CITY OF ALBUQUERQUE

**RE: Mister Car Wash - 98th St. & Volcano Rd.
Grading and Drainage Plan & Drainage Report
Engineer's Stamp Date: 03/14/19
Hydrology File: K08D004**

Based upon the information provided in your submittal received 03/14/2019, the Grading & Drainage Plan and Drainage Report **is not** approved for Building Permit, Grading Permit, Work Order, and for action by the DRB on Platting and Site Plan for Building Permit. The following comments need to be addressed for approval of the above referenced project:

SHEET #
C3

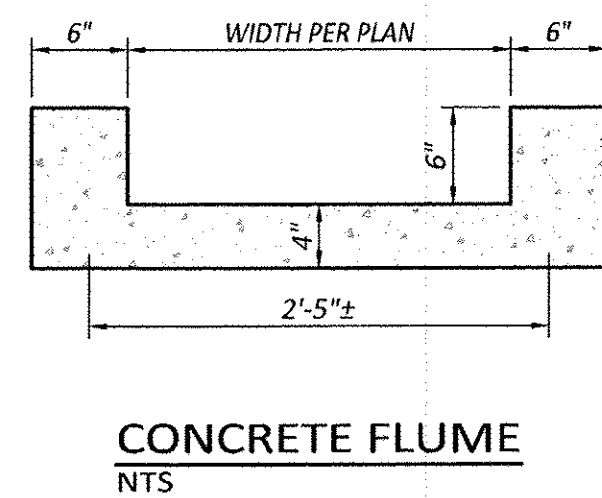
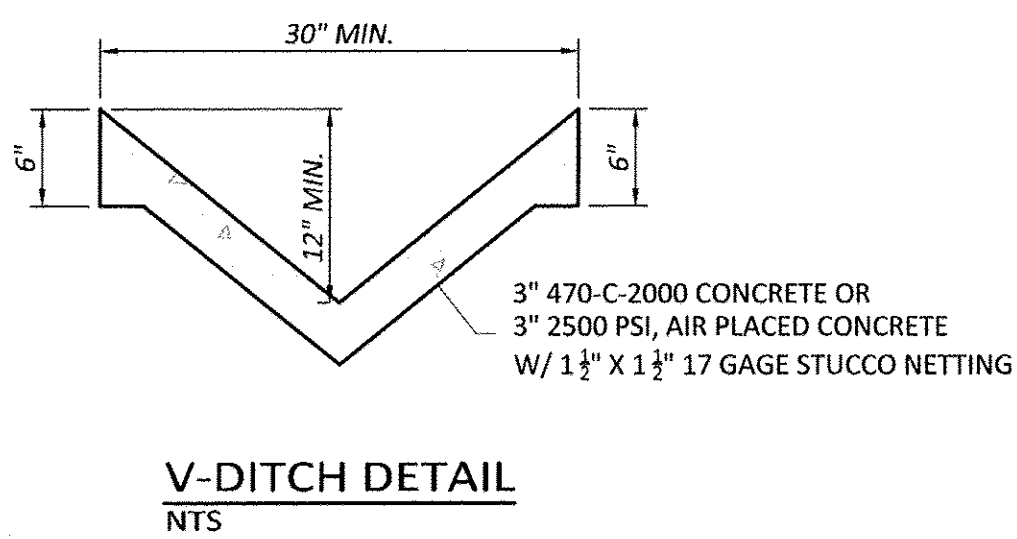
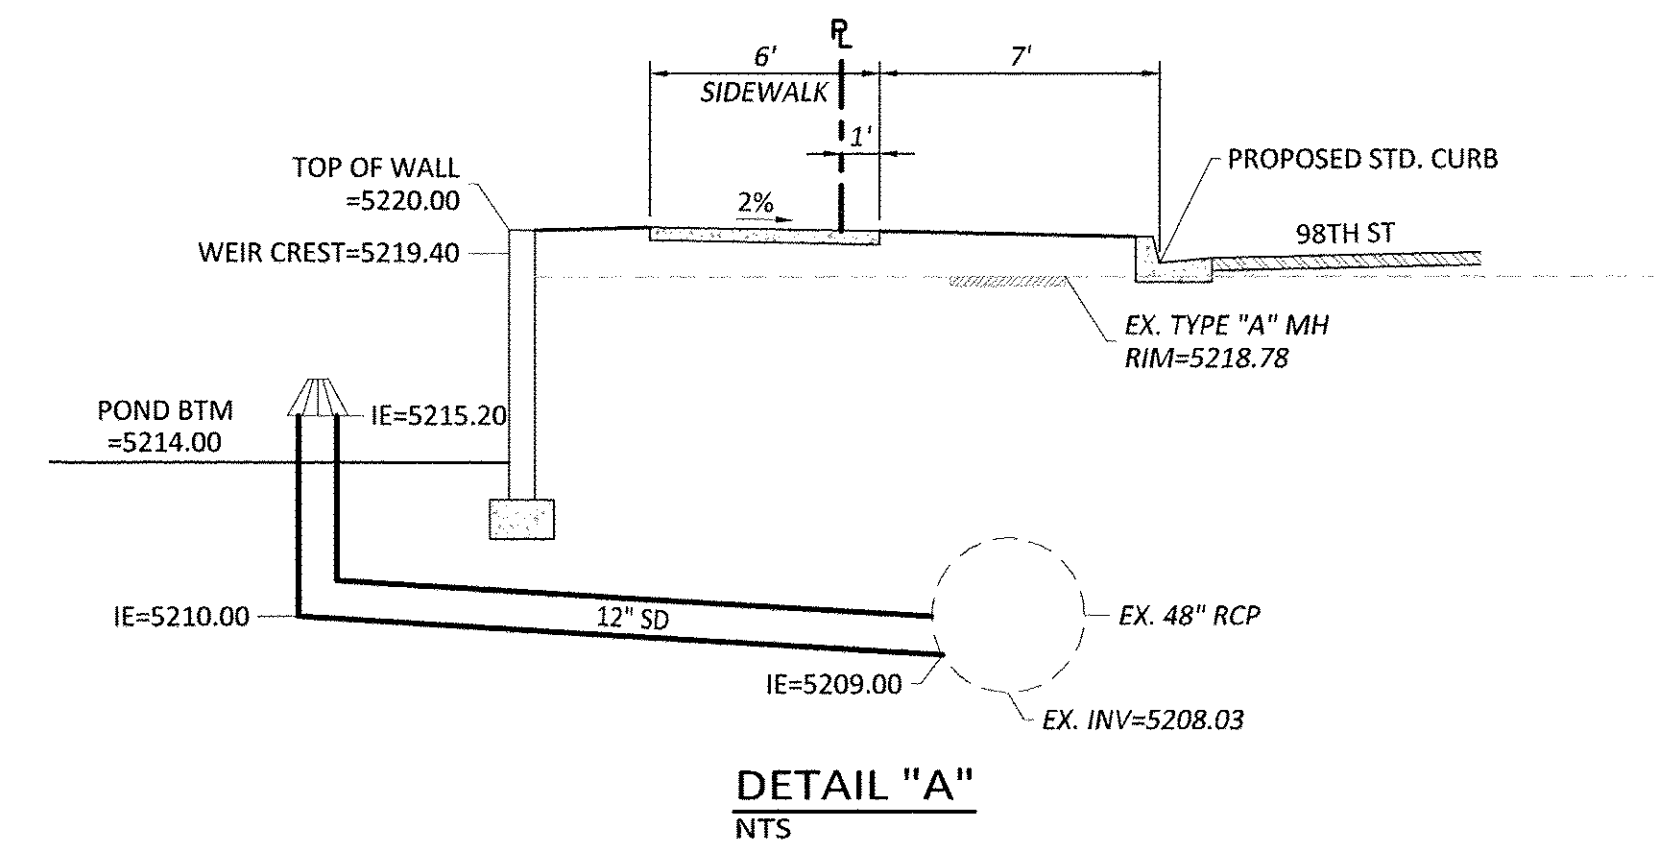
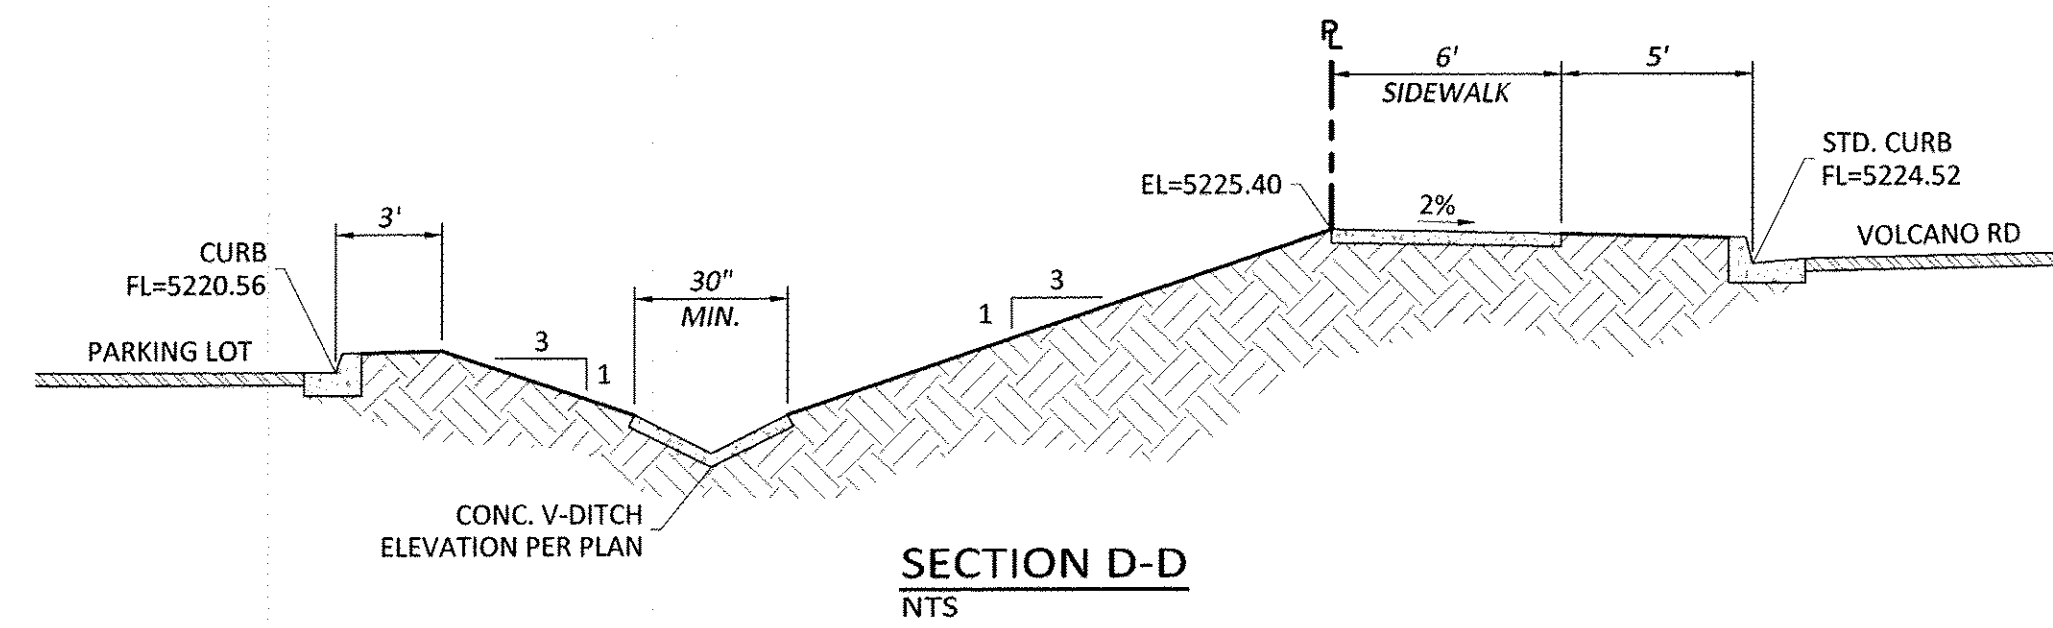
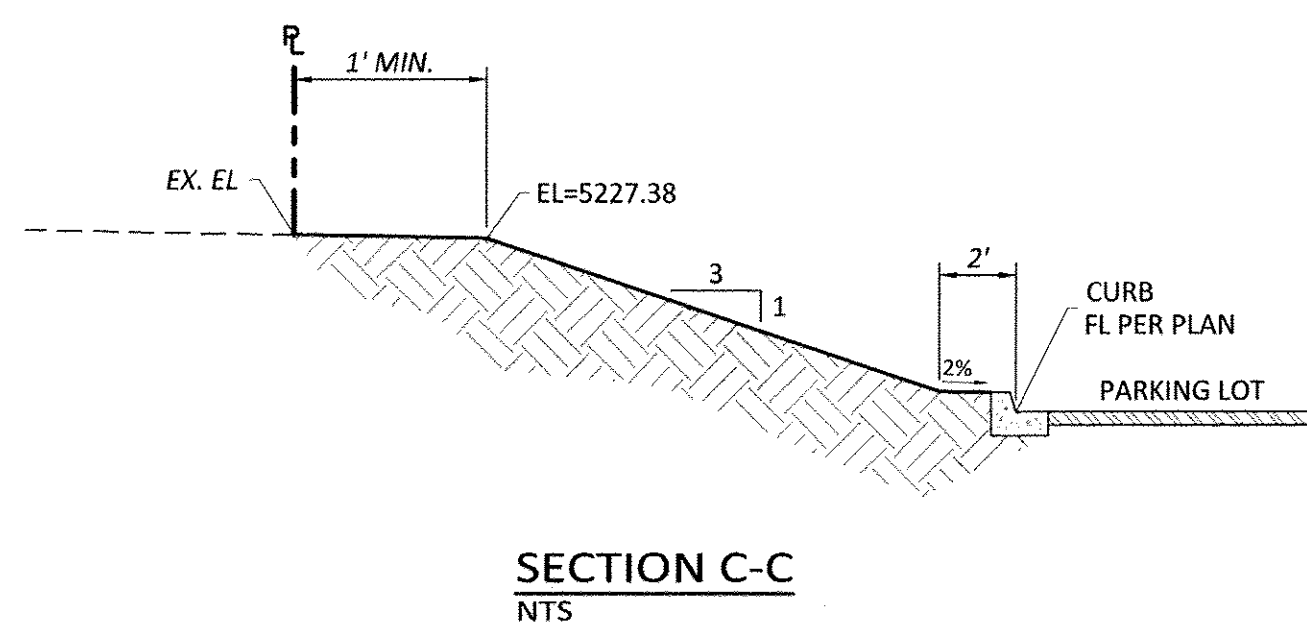
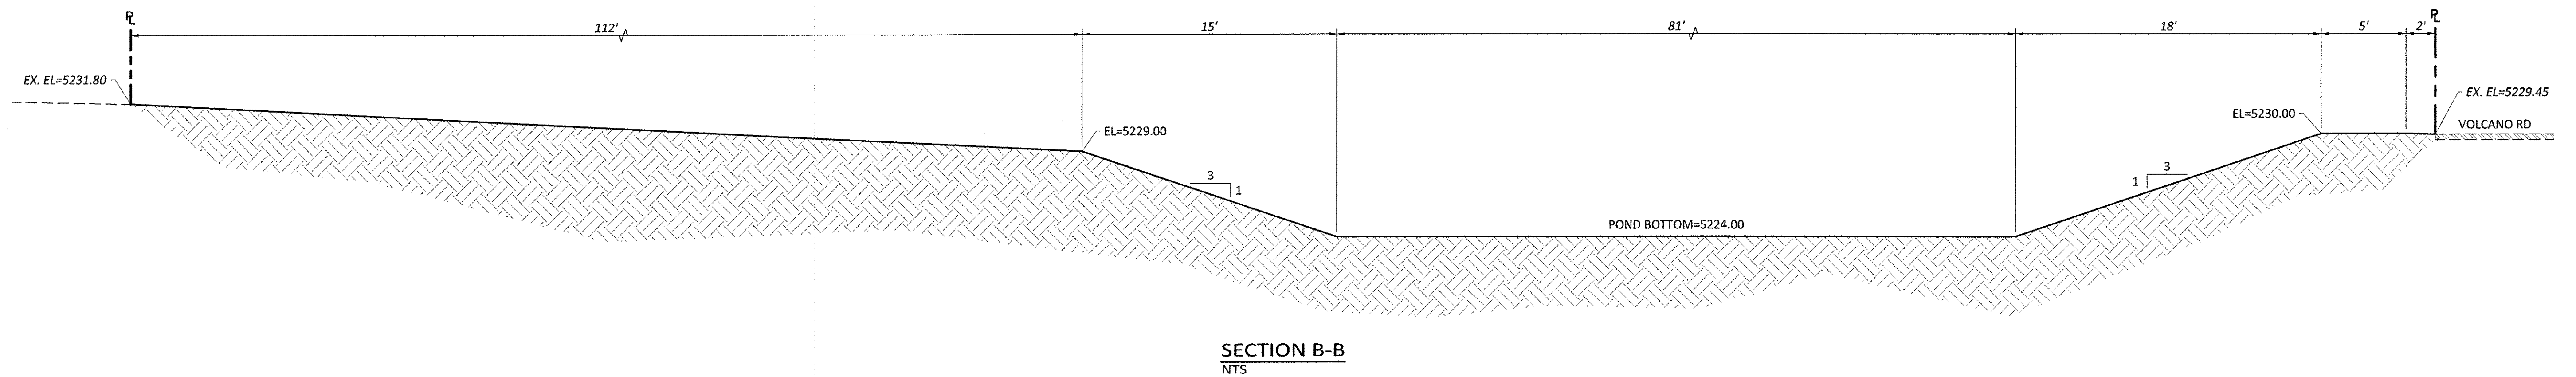
13. Sheet C4 - Detail "A". Either change the pipe from HDPE to RCP or add a converter from HDPE to RCP at the R.O.W. and add the detail from ADS.
14. Please remove Sheets C3 and C5 from further submittals to Hydrology. These are not needed.
